AMENDMENTS TO THE DRAWINGS:

REMARKS

This communication is a full and timely response to the final Office Action dated June 19, 2008. Claims 1-15 remain pending, where claims 7-9 are withdrawn. By this communication, claims 1-15 are amended. Support for the amended subject matter can be found, for example, at page 8, lines 11-23, page 9, lines 21-26 and Figs.2 and 3 of the Applicant's disclosure.

Fig.1.

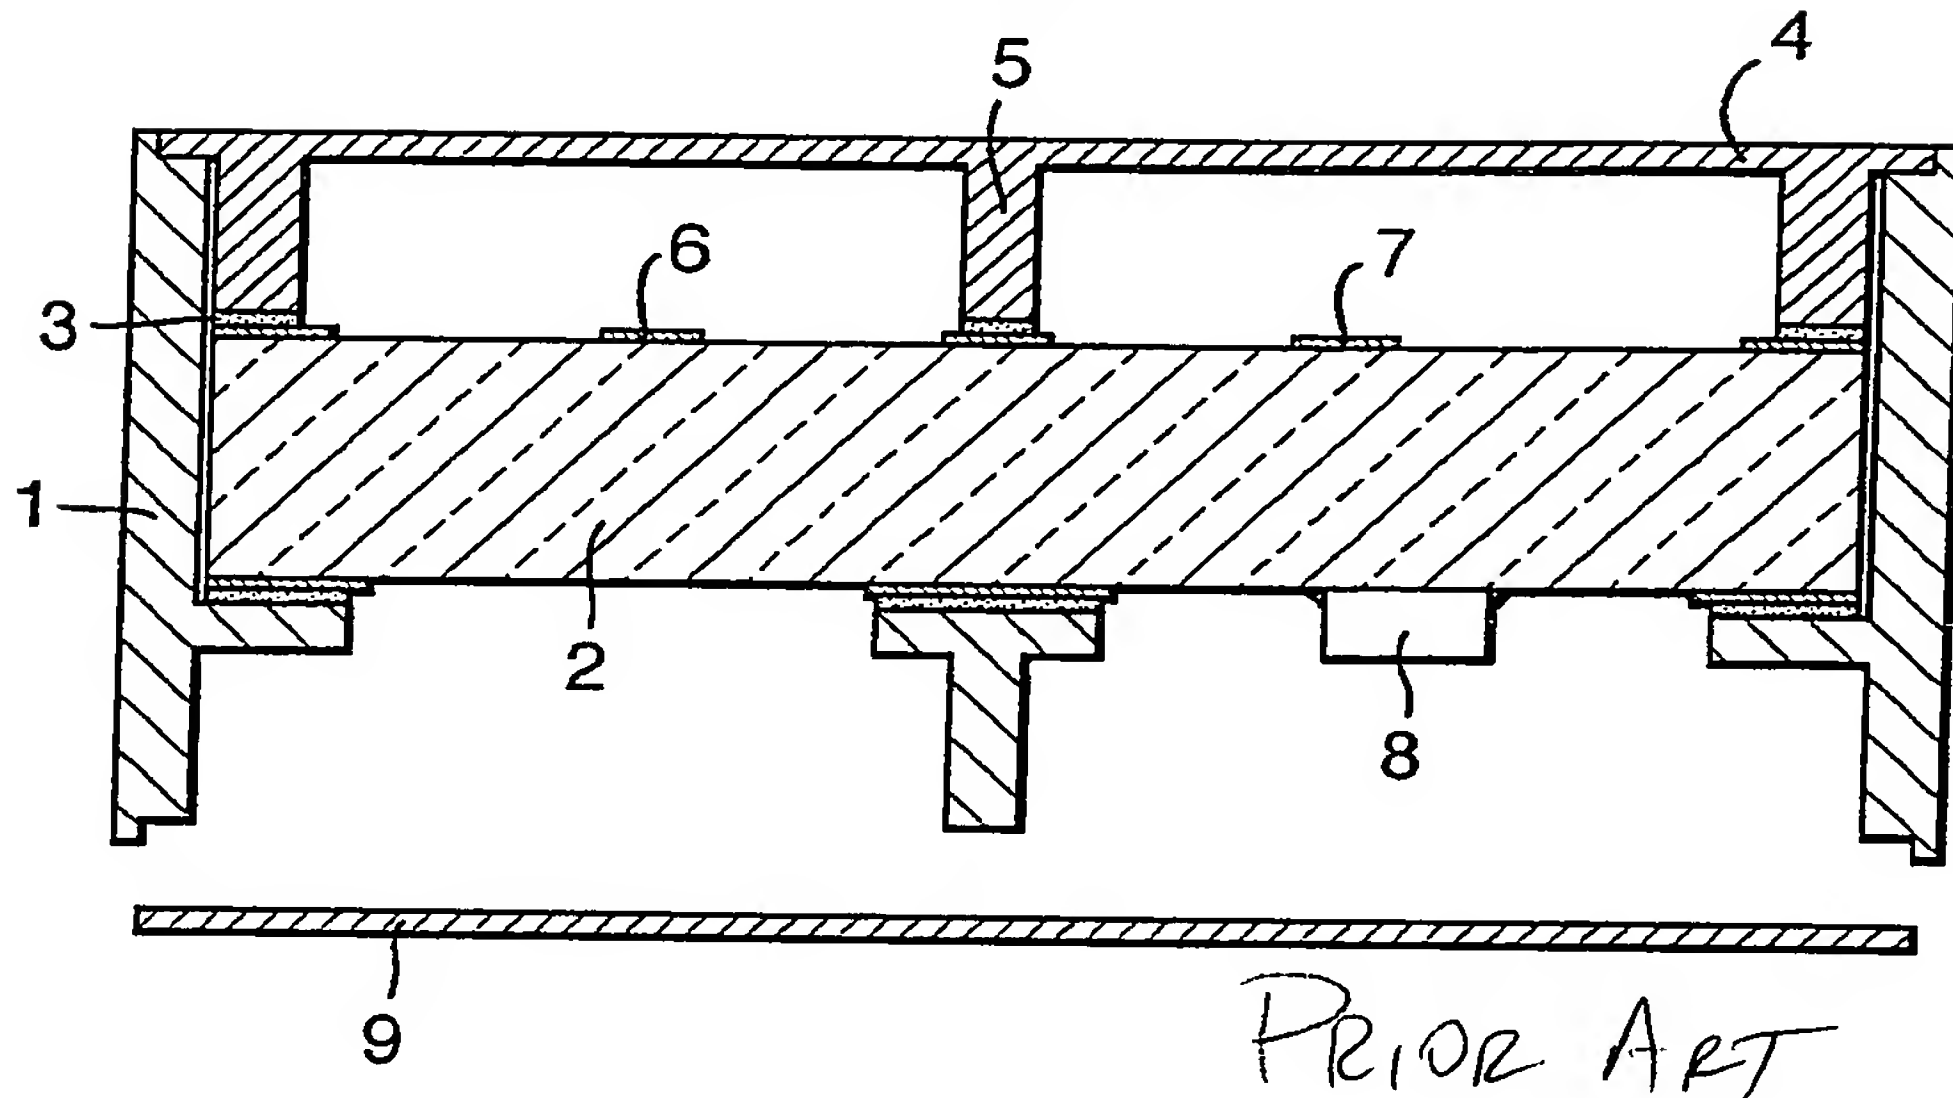
The attached drawing sheet includes changes to Figure 1 and replaces the original sheet including Figures 1-3. Specifically, the legend "PRIOR ART" has been added to Figure 1.

In numbered paragraph 4 on page 3 of the Office Action, Figure 1 is objected to for allegedly failing to include a "Prior Art" legend. Applicant appreciates the Examiner's diligence and has amended Figure 1 to include the "Prior Art" legend. Withdrawal is respectfully requested.
